**DEALER BULLETIN**

**SLR/031/99**

**TECHNICAL BULLETINS**

# TECHNICAL BULLETIN

**DAMAGE TO CHASSIS ELECTRICAL HARNESS**

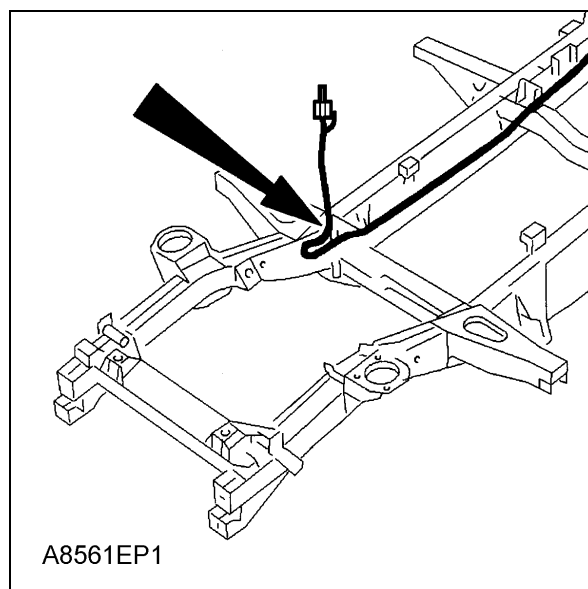
**Chafing damage to the harness, possibly resulting in electrical failures.**

**If incorrectly routed a loop of harness can foul on the front propeller shaft.**

**When replacing a damaged harness or carrying out any repairs in the vicinity of the exposed chassis harness / front propeller shaft, ensure on completion of work, that the harness is correctly routed to give adequate clearance.**

- **With the battery disconnected and the vehicle raised, from beneath the vehicle locate the harness in the area above the front differential and right hand chassis longitudinal.**
- **The harness emerges below the body and enters the right hand chassis longitudinal. Between these two points there is a loop in the harness, (arrowed in illustration), which *MUST* be clear of the propeller shaft.**
- **To ensure correct installation, locate the white marker tape around the harness. This indicates the point at which the harness and grommet should enter the chassis. Feed the harness into the chassis until this is achieved.**

- Confirm that there is now adequate clearance between the harness and the propeller shaft. ***ON NO ACCOUNT*** must the harness be cable tied to any fuel or brake pipes above the chassis.
-
